Groundwater Application Review Summary Form

Application # LL- 1872 Re-Review

SUBJECT: Application LL- 1872 Re-Review Supersedes review of 11/15/2021 Date of Review(s)

A. GENERAL INFORMATION: Applicant's Name: Avion Water Co. Inc. County: Deschutes

Figure 2. Hydrograph of groundwater elevations from the Sisters area through the Deep Canyon area. DESC 2000 and DESC 1416 are 0.8 and 2.9 miles from the proposed POAs, respectively.

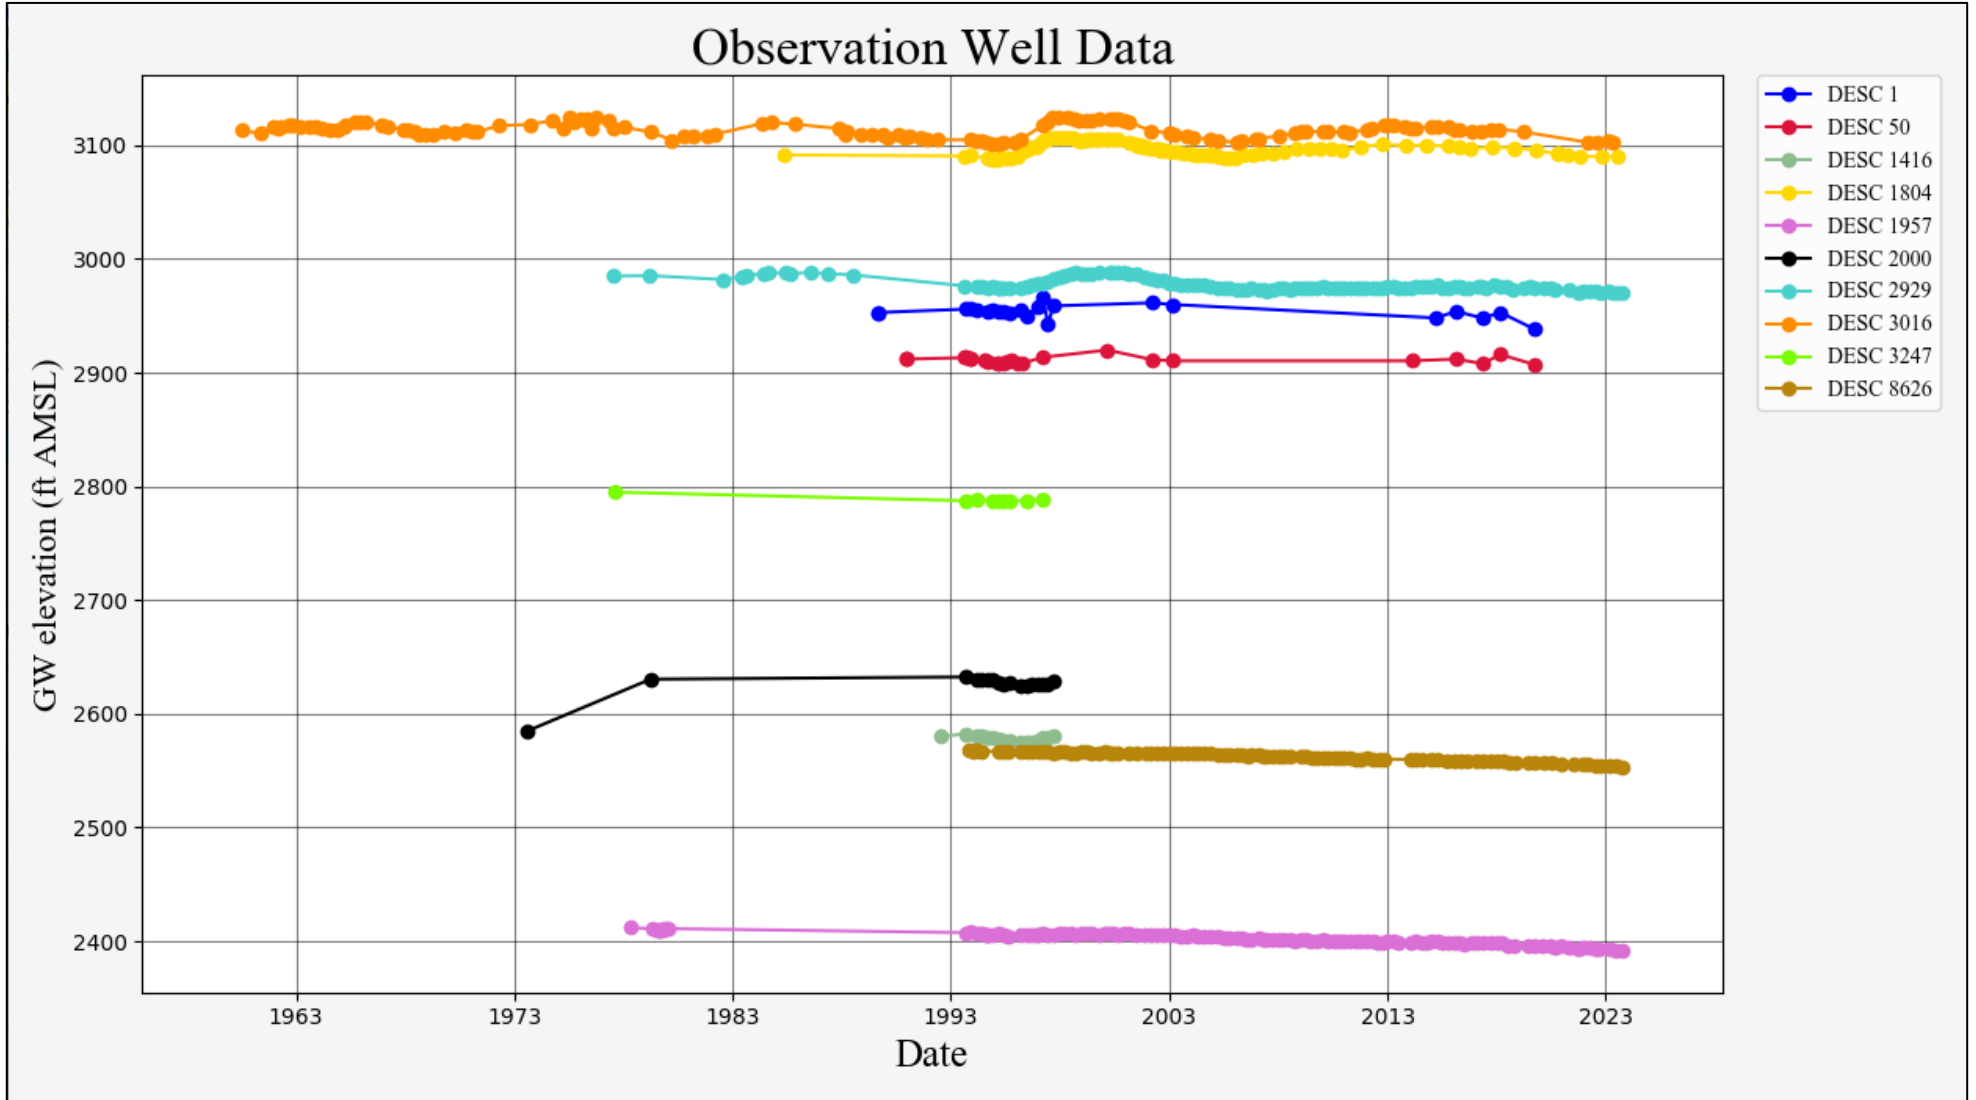
Several wells to the east of the proposed POAs (referred to as the “Deep Canyon Area” in Map 1) have shown persistent year-on-year declines totaling ~13 feet from 1994 to 2023 (see Figures 3 and 4). Studies by the USGS and OWRD have attributed these long-term declines to 1) long-term climate change, 2) groundwater pumping (see Figure 2), and 3) canal lining causing reduced recharge. The nearest well (DESC 1957) exhibiting this trend is approximately five miles to the east of the proposed POAs. Wells upgradient in the groundwater system from the city of Sisters (e.g. DESC 3016 and DESC 1804) show 10-20 feet of oscillation that tracks largely with decadal climate cycles. Current groundwater levels in those wells are at or near the same elevation as 1994. Just downgradient (NE) of Sisters, water levels in DESC 2929 rise 12-13 feet

in response to the heavy precipitation of the late 1990s but respond very little to increased recharge in the early 2010s. Current water levels are ~5 feet lower than in 1994. There are no long-term observation wells immediately adjacent to the proposed POAs that show water level trends there. Because the proposed POAs are located nearly equidistant between DESC 2929 and DESC 1957 in the same groundwater system, this review assumes that water levels at the application site show an intermediate of those two trends. Specifically, water levels have likely shown declines since approximately 2000 on the order of 5-10 feet.

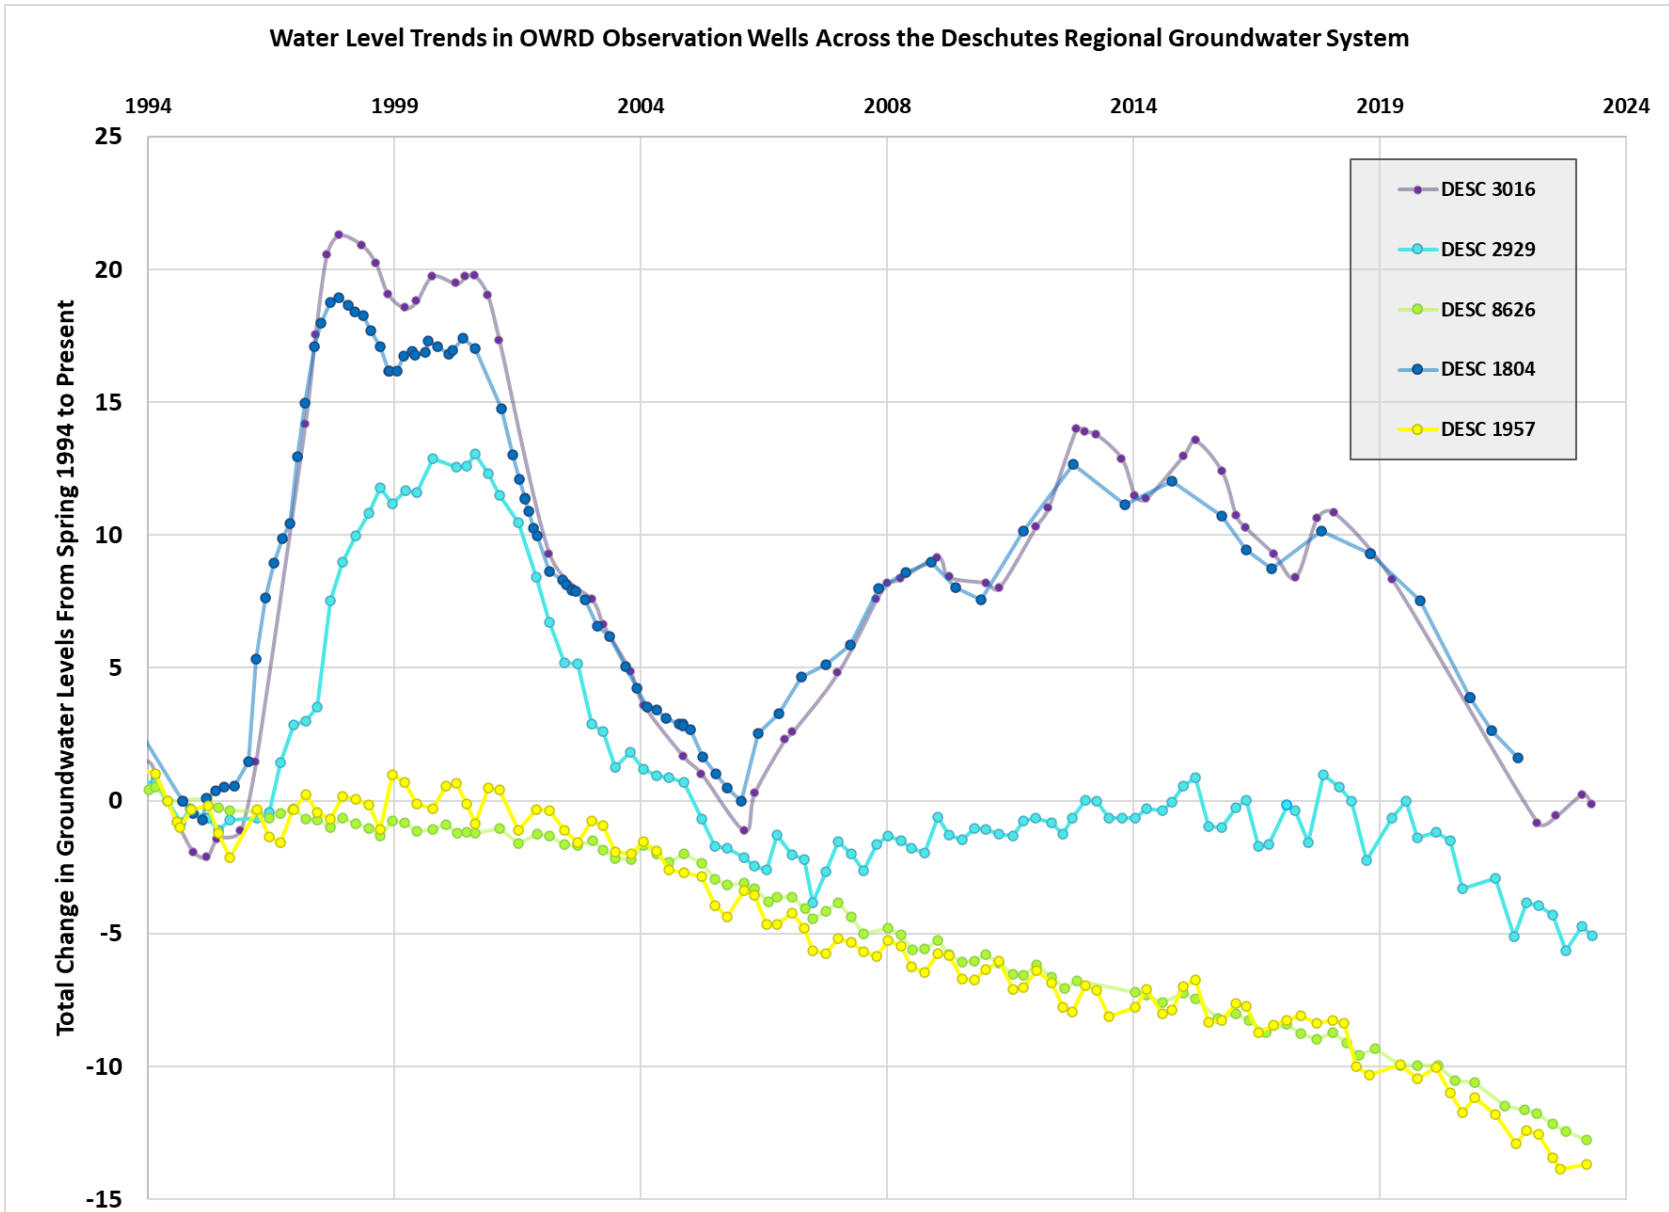
The wells in the Deep Canyon area showing long-term water level declines are located generally down-gradient of the proposed POAs and thus farther from recharge zones for the region. Pumping under the proposed right would reduce recharge to the Deep Canyon Area by intercepting the dominate groundwater flowpaths to this area, thus exacerbating the declines there. However, considering the low-moderate magnitude of declines observed in the Deep Canyon area and assumed at the proposed POAs, the preponderance of evidence indicates that the proposed use is within the capacity of the resources. There best available water budget estimates from USGS basin study reports indicate that the resource is not over-appropriated. In light of the lack of data in the area and concern about longer term declines, the permit conditions listed in Section B(d) are strongly recommended.

Prior to use under this Limited License, each POA shall be equipped with a method for measuring static water level and a reference water level must be provided to the Department. This can include an airline, measuring tube, or any other construction or equipment that allows access to report static water level measurements. The chosen water level measuring method shall be maintained in proper working order as to allow static water level measurements for the duration of the Limited License.

Figure 5: Extract from Gannett et al. (2017); results of modeling impacts from pumping a well completed in the Deschutes Formation aquifer on nearby surface water reaches; purple squares show the impacted model stream cells.

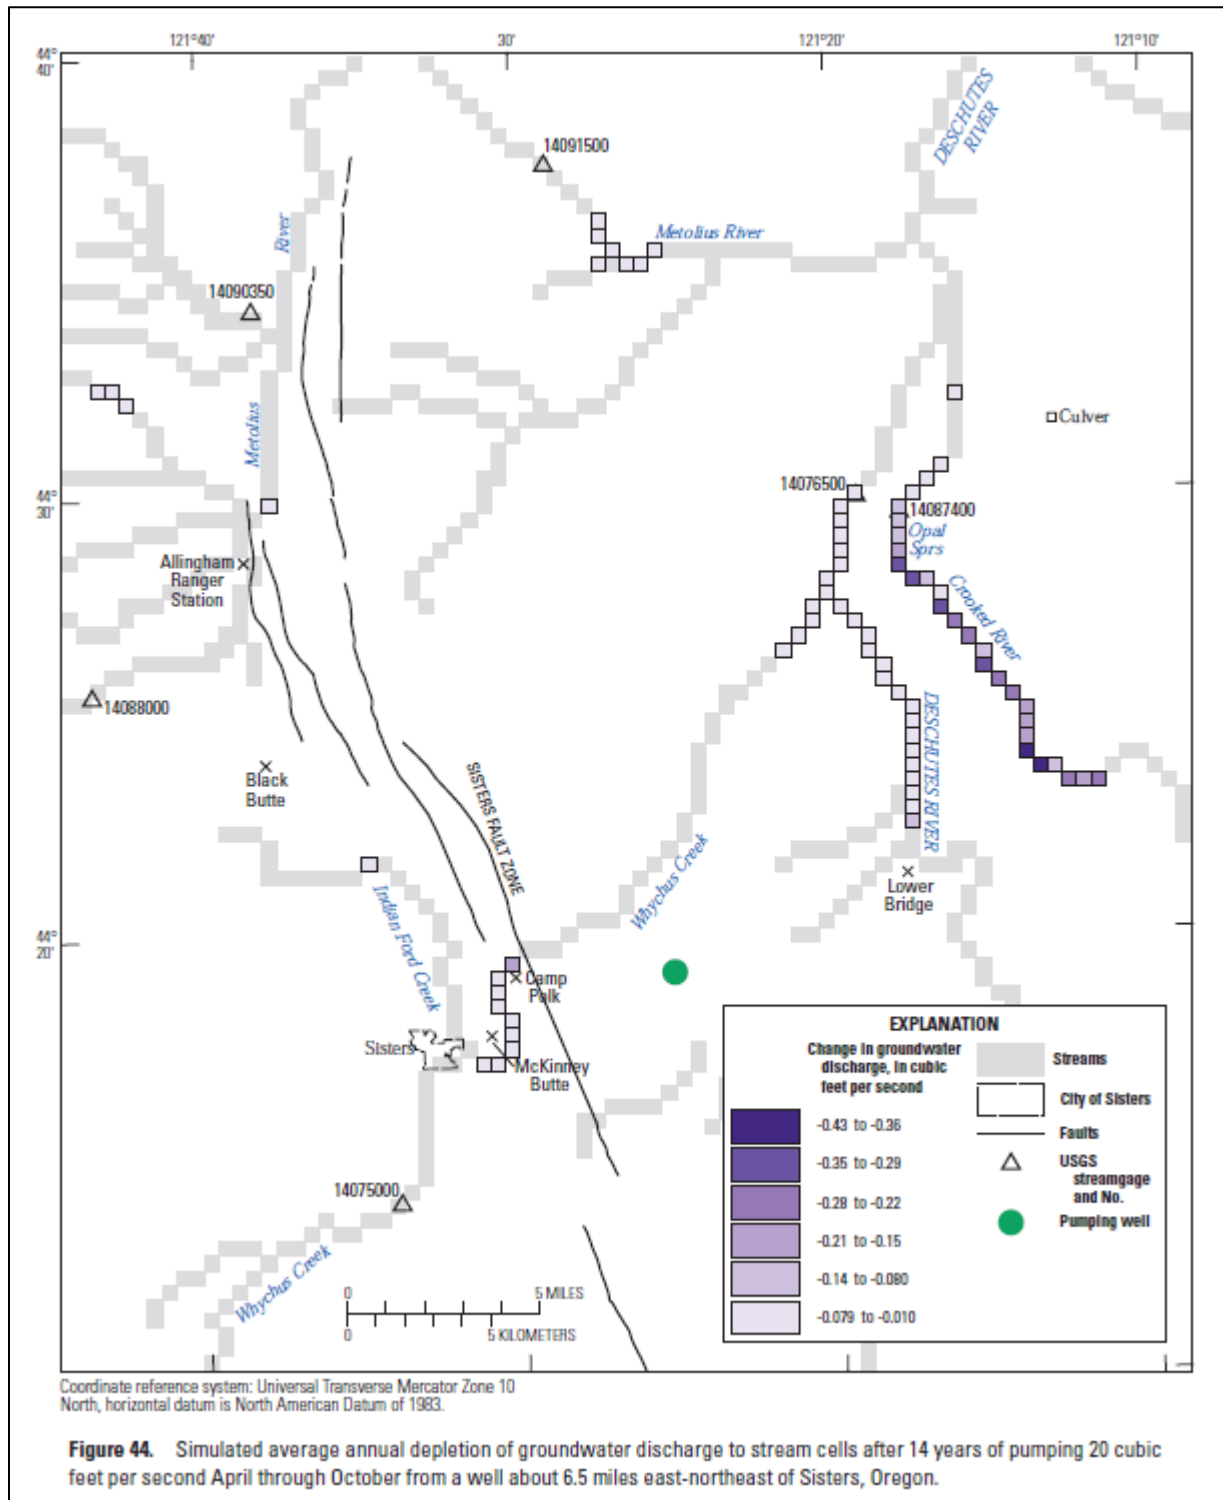
Basis for impact evaluation: Analytical stream depletion models, such and the Hunt-1999 model, would not be appropriate at this distance, so stream depletion was based on the results of modeling done as part of the USGS Scientific Investigations Report 2017-5097 (Gannett et al., 2017). Specifically, pages 61-63 describe modeling stream depletion impacts from pumping a well near the area of the proposed POAs and Figure 44 and 45 show the impacts to Whychus Creek, the Deschutes River, and the Crooked River. The analysis estimates that stream depletion will be less than 5 % after 1 year of pumping for all three surface water sources. The resolution of the figure is too coarse to confidently pick out stream depletion less than 5% and less than 1 year so those values are used in the table.

C6. SW / GW Remarks and Conditions: Studies in the Deschutes Basin have shown that there is strong hydraulic connected between groundwater and surface water in the area of the proposed groundwater POAs but that there is little hydraulic connection in the immediate vicinity. Instead, groundwater flows hundreds of feet below land surface in the middle part of the Deschutes Basin, an area extending from near the Sisters Fault Zone to near the confluences of the Deschutes River, Crooked River, and Whychus Creek. These same studies have shown that nearly all groundwater flowing through the area does discharge back to surface water so the total impact from pumping near the proposed groundwater POAs will, over time, likely reach 100% of the pumping. However, in the short time scale considered in this review (limited to assessing impacts within 1 year) the impact to surface water is estimated to be less than 5% of the pumping rate and so is not considered to have the Potential for Substantial Interference with surface water per OAR 690-009 rules.
